HYDROGRAPHIC TITLE SHEET

H-9724

Locality HILLER COVE TO INDIAN NECK

DESCRIPTIVE REPORT
TO ACCOMPANY SURVEY

CHART 13236
21st Ed. June 27, 1981

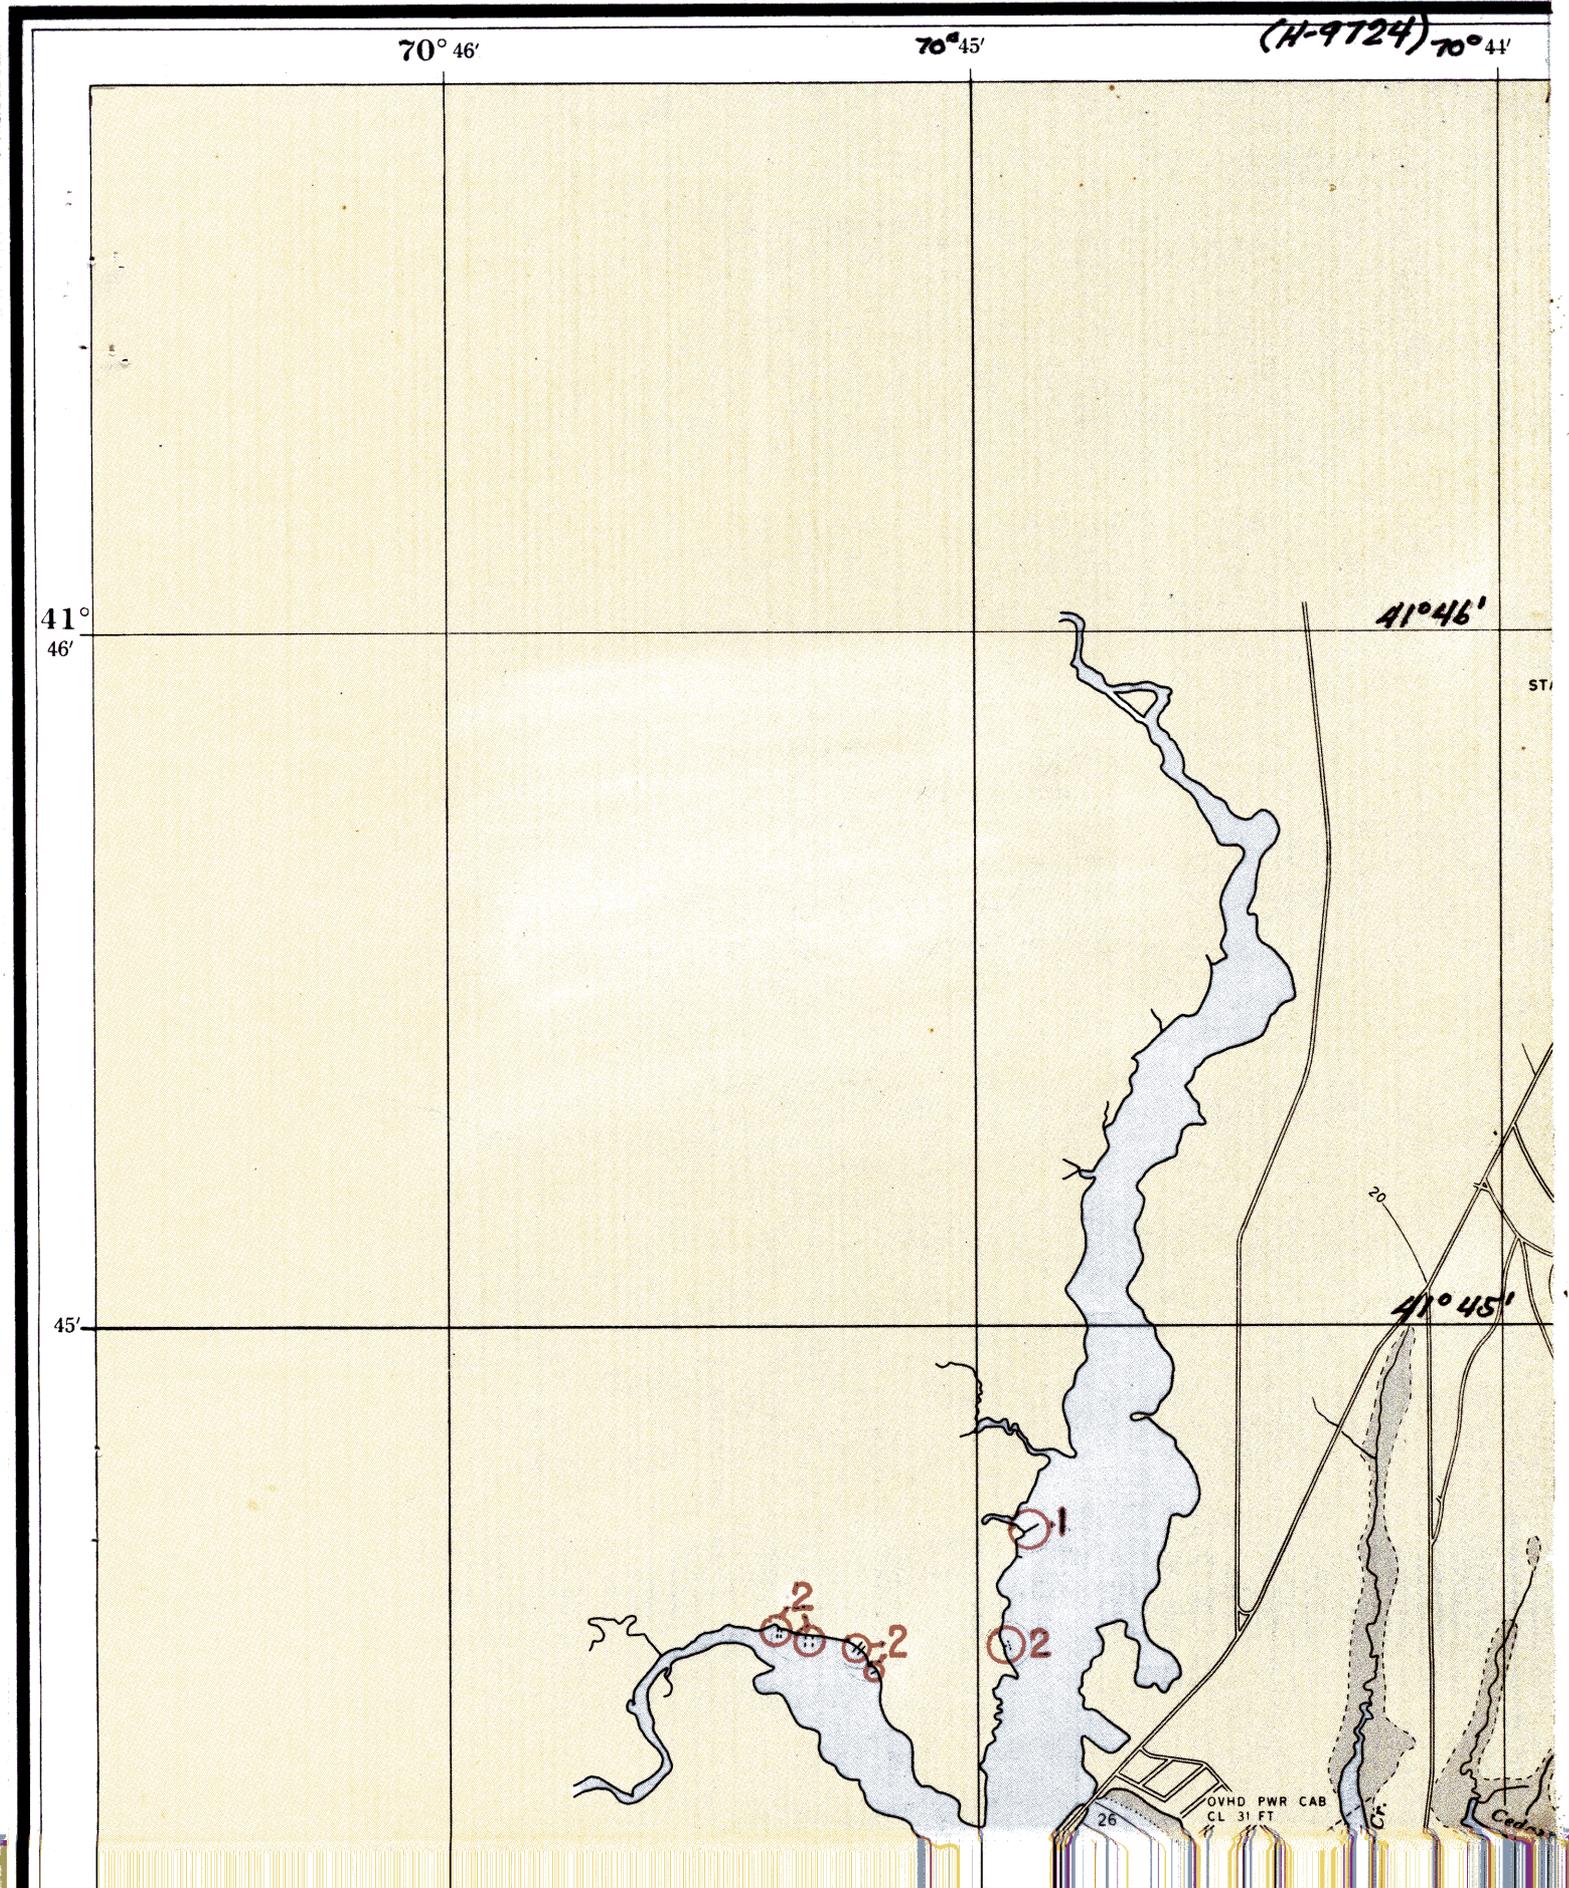
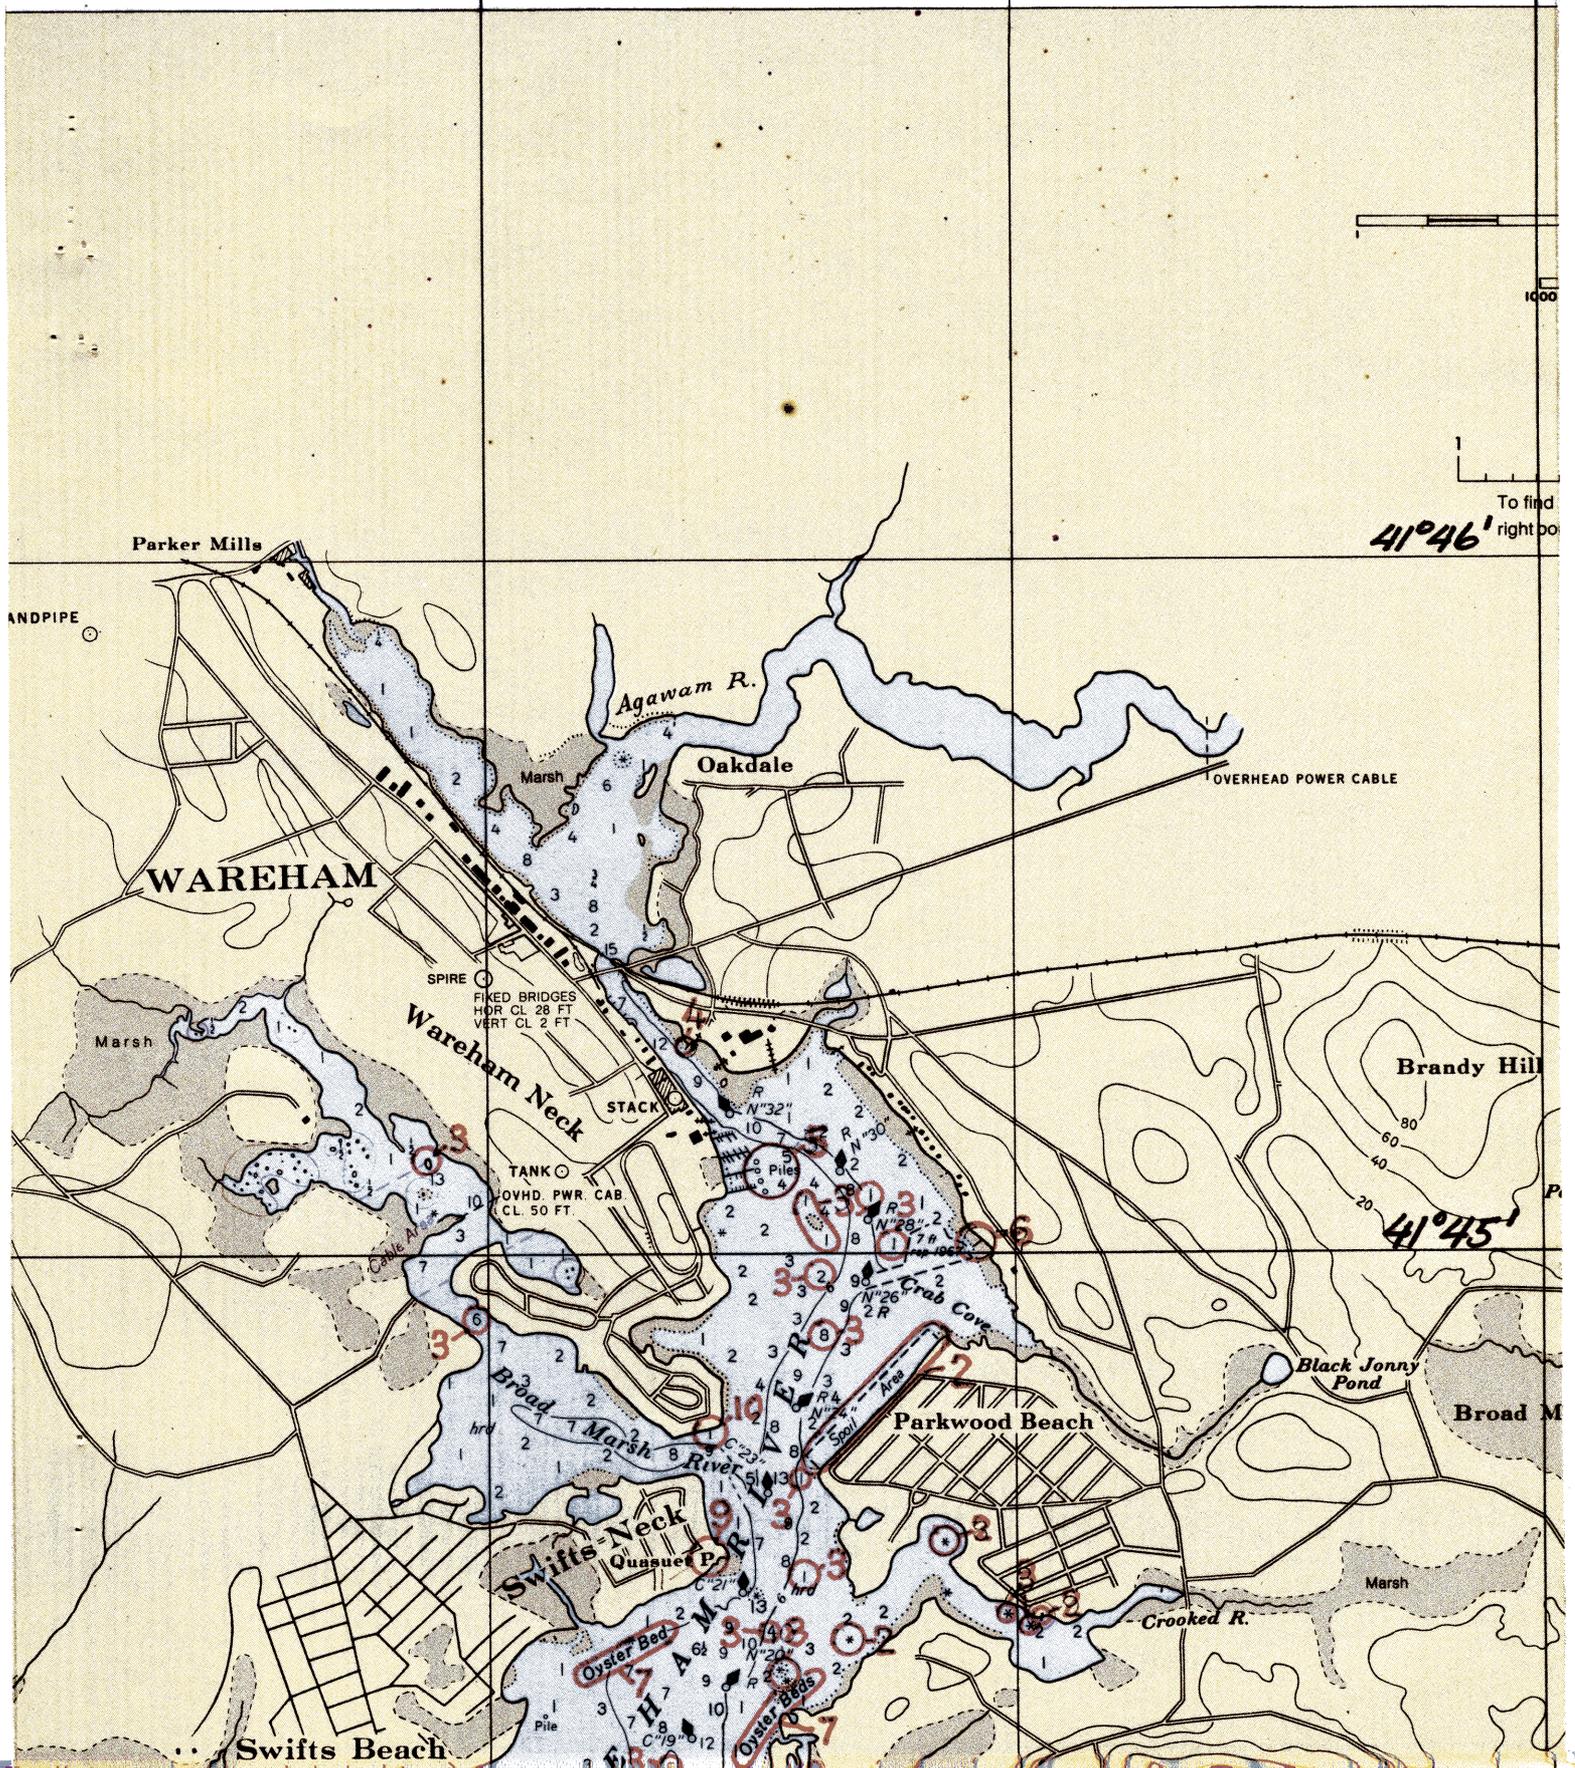
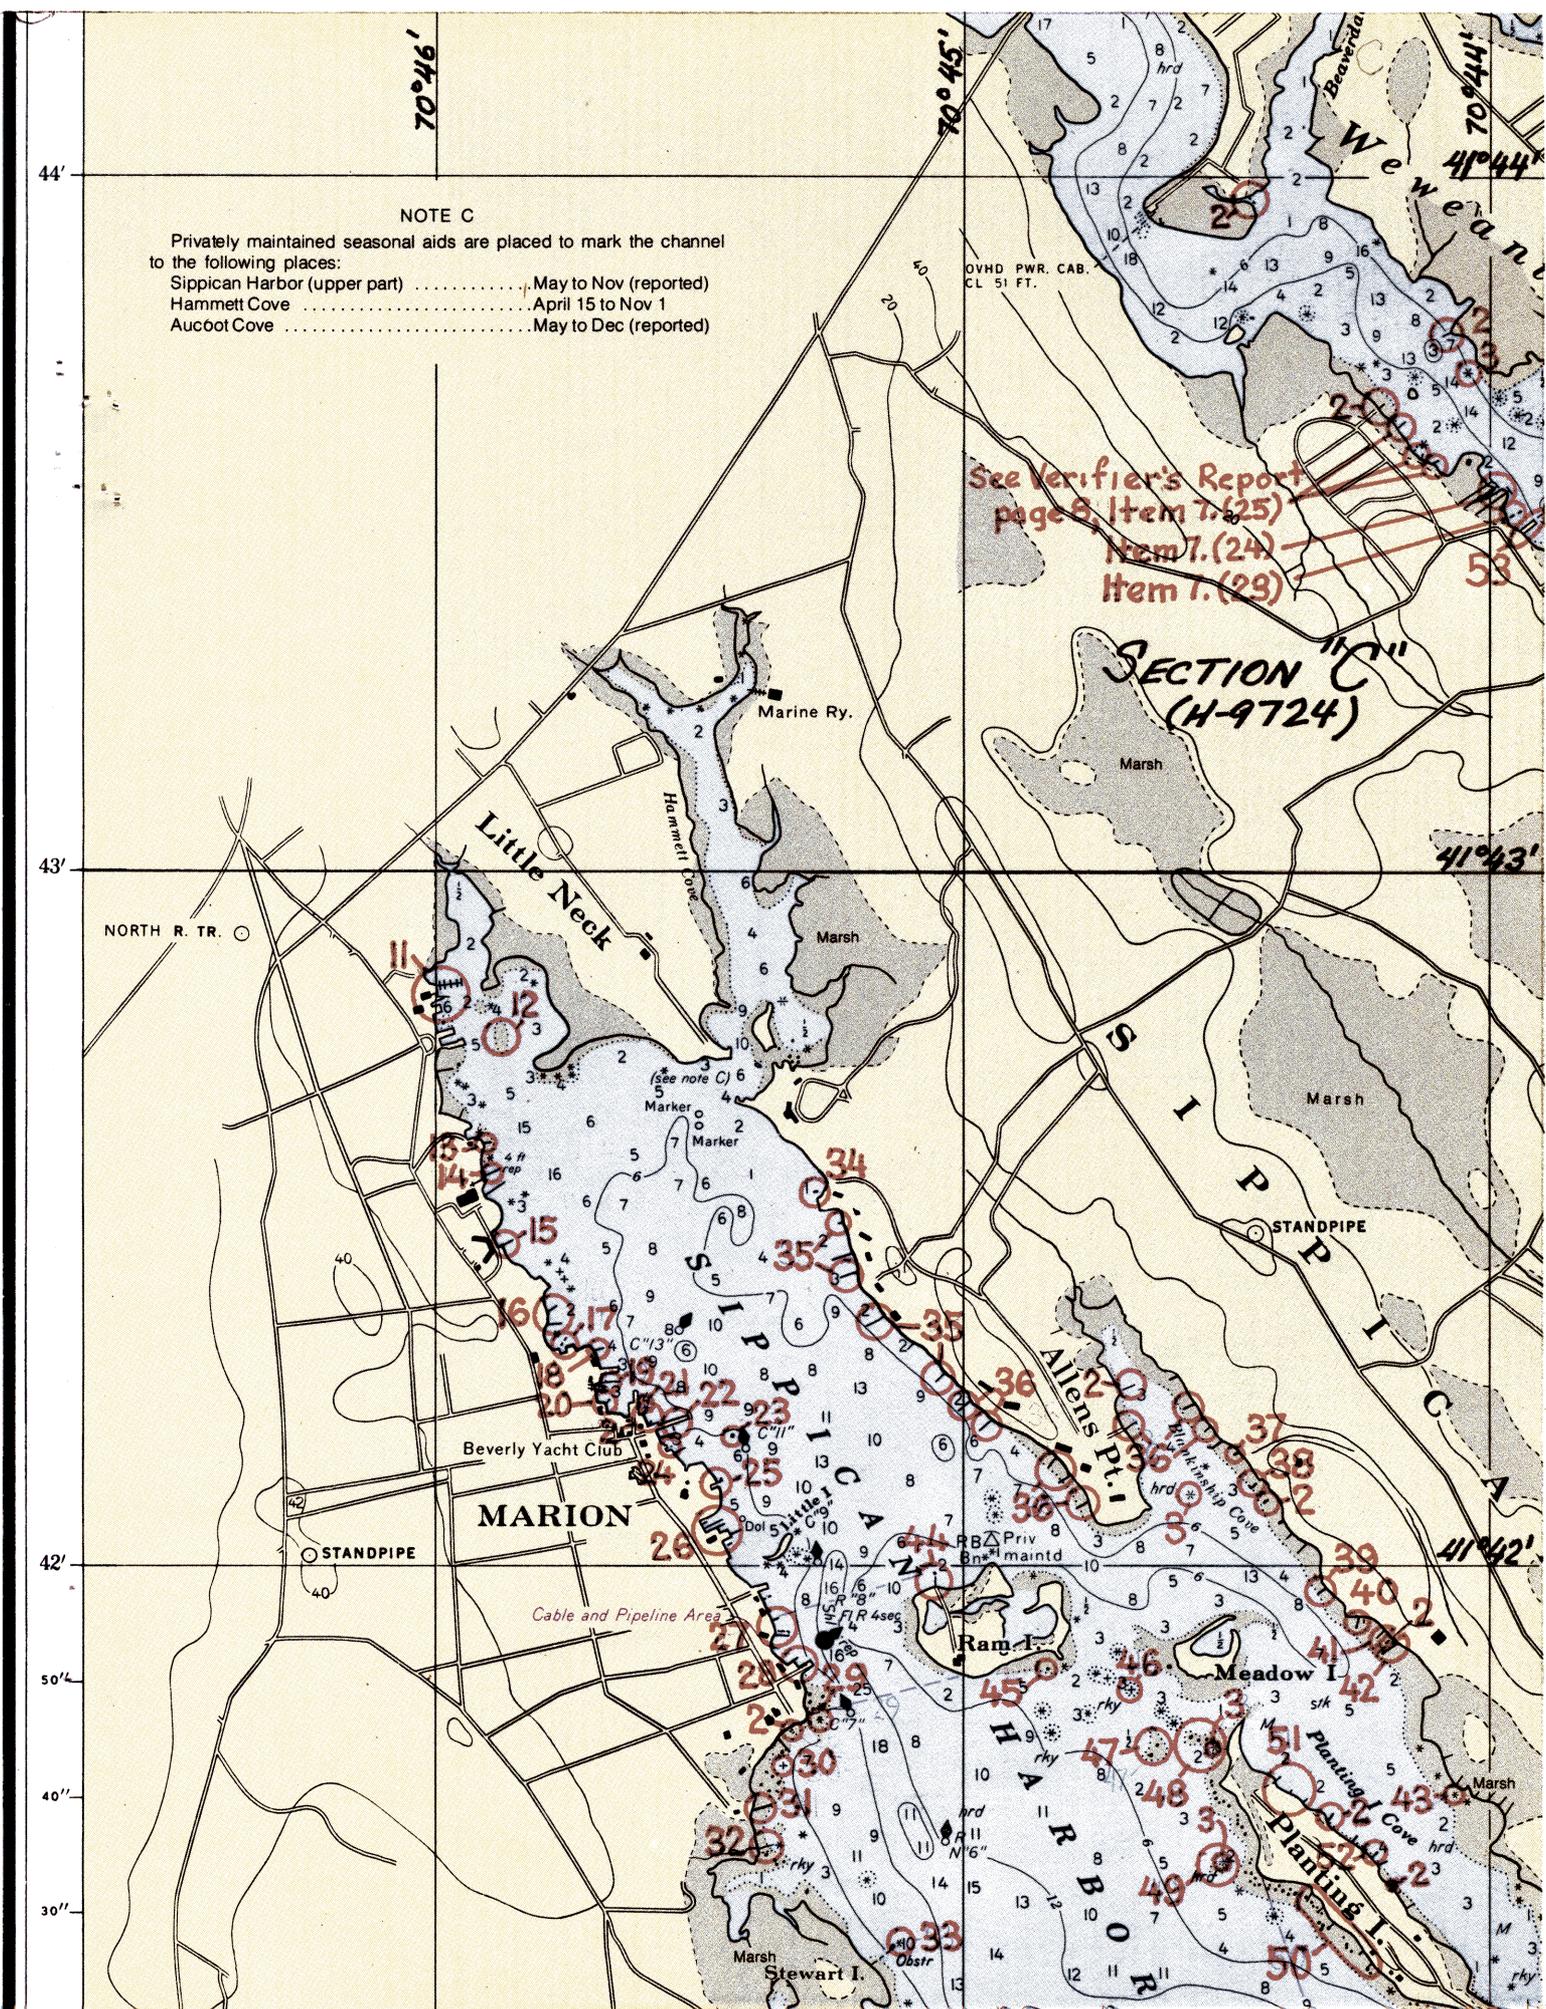
24. A comparison between the present survey and Chart 13236, 21st Edition, dated June 27, 1981, was made during quality control inspection in order to provide additional guidance to the nautical chart compiler. Many charted items have not heretofore been addressed. The attached six chart sections contain numbered items cross-referenced to the following numbered recommendations:

(9) The geographic name "Quasuet Pt." is mistakenly charted as "Quasuet P"--revise the new chart edition accordingly.

- (20) Pier is charted from a miscellaneous source. Shoreline change suggests cultural improvements in this area. Recommend expunging the charted pier.

- (25) The delineation of the "L" pier, charted from a miscellaneous source, is in conflict with the delineation shown on TP-00764 (1974-79). The Class I map delineation is considered questionable. A charting resolution is deferred to the chart compiler.

(60a) A 13-foot sounding or soundings of 1 and 3 feet is/are charted from a miscellaneous source. Expunge the questionable item and chart depths in the area as shown on the present survey.

(74) The pier and questionable marks connected to the shoreline are charted from a miscellaneous source. Chart the area as shown on the present survey.

(84 and 85) One-foot soundings charted from H-2272 (1896) are labeled "rock" on their source. Rocks awash, covered 1 foot at MLW, were carried forward to the smooth sheet. Chart the appropriate symbol instead of the 1-foot soundings.

(86) The 8-foot sounding, charted from H-2272 (1896), is labeled "rock" on the original source. The 8-foot sounding with "Rk" appended was carried forward to the present survey and should be charted as shown on the smooth sheet.

(88) The 2-foot sounding charted from H-2272 (1896) is labeled "rock" on the original source. This item was carried forward to the smooth sheet as a 2-foot sounding with "Rk" appended and should be charted as such.

- (100) The 1-foot sounding, charted from H-2272 (1896), is identified on the original source as a rock. A rock covered 1 foot at MLW was carried forward to the smooth sheet. Chart the appropriate rock symbol.

- (101) The geographic name "Seal Rocks" is charted in vertical letters denoting bare rocks. There are no bare rocks on the present survey in this area. Revise the charted letters from vertical to slanted.

- (104) Revise the charted double line delineation of this item to a single line delineation as shown on the present survey.
- (105) The 3-foot sounding, charted from H-2272 (1896), is identified as a sunken rock on the source. A 3-foot sounding with "Rk" appended was carried forward to the smooth sheet and should be charted as such.

- (108) Ruins originate with a pier on T-2215 (1895). The charted ruins are not noted in the present survey records and fall within a foul area delineated on the smooth sheet. A charting resolution is deferred to the chart compiler.

- (112) The 2-foot sounding, charted from H-2272 (1896), is identified on the original source as a rock. The 2-foot sounding with "Rk" appended was carried forward to the smooth sheet and should be charted as shown on the smooth sheet.

- (113) Chart the locations of the groins as shown on the present survey.
- (114) The 1-foot sounding, charted from H-2272 (1896), is identified as a rock awash covered 1 foot at MLW on the original source. This rock awash was not shown on the smooth sheet since it falls within the limits of a foul area delineated on the smooth sheet.

- (121) Chart locations of rocks awash in this area as shown on the present survey.
- (122 through 124) The 17-, 2-, and 4-foot soundings charted from H-2272 (1896) are identified on the original source as submerged rocks. The three soundings with "Rk" appended to each were carried forward to the smooth sheet and should be charted as shown on the smooth sheet.

- (125) The 16-foot sounding, charted from H-3391 (1912-14) WD, is identified on the original source as a submerged boulder. The 16-foot sounding with "Bld" appended was carried forward to the smooth sheet and should be charted as shown on the smooth sheet.
